# UNITED STATES PATENT AND TRADEMARK OFFICE

DATE MAILED: 05/27/2004

This is the first office action for application number 10/726,818, Tableware Clip-On Device, filed on December 3, 2003.

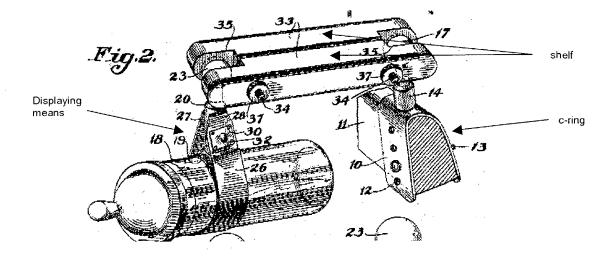
Claims 4-6 are rejected under 35 U.S.C. 102(b) as being anticipated by U.S. Patent number 1,590,227 to Britton.

Britton '227 discloses a clip-on device (above) comprising a c-ring (above) integral with a rearwardly (depending upon a user's specific reference point) extending shaft (15,16, "integral" is defined in Merriam Webster's Collegiate Dictionary - 10<sup>th</sup> Edition as "formed as a unit with another part," so clearly the ring is integral with the shaft), wherein a distal end of the shaft is connected to a ball (17), a means (36) for movably gripping the ball and supporting a shelf (above), and a displaying means (above), wherein the gripping means is a frictionally engaging partial circular member, wherein the displaying means is a clamping device mounted on the shelf (via 22, 23 and 36).

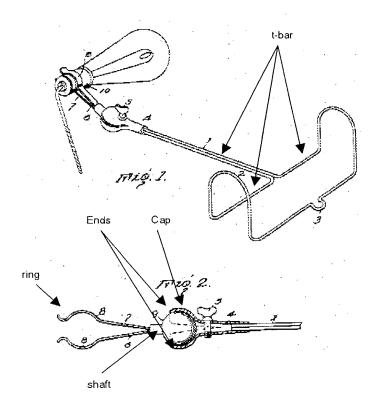
Claim 1 is rejected under 35 U.S.C. 103(a) as being unpatentable over Barnes '894.

Barnes '894 discloses a clip on device (above) comprising a ring (above) integral with a shaft (above, utilizing same definition of "integral" from above) extending away from a back end of the ring, the shaft connected to a ball (9) at a point distal from the ring, a partially circular cap (above) supporting a t-bar (above) on an exterior surface distal from an opening between a pair of ends (above) on the circular cap, the t-bar supporting a pair of spreadable lips (above, they are inherently "spreadable" since the

wire can be "bent", see lines 42-44), wherein the ring is partially a c-ring, and partially a v-ring. However, Barnes '894 fails to specifically teach the ring to be a c-ring. It would have been obvious to one of ordinary skill in the art at the time the invention was made to have constructed the ring of any of numerous shapes, including a c-shaped ring, so long as it still securely fastens to an object, since the particular shape claimed by the applicant is nothing more than one of numerous shapes that an ordinary artisan provides for using routine experimentation based on its suitability for the intended use of invention. See In Re Daily, 149 USPQ 47 (CCPA 1976).
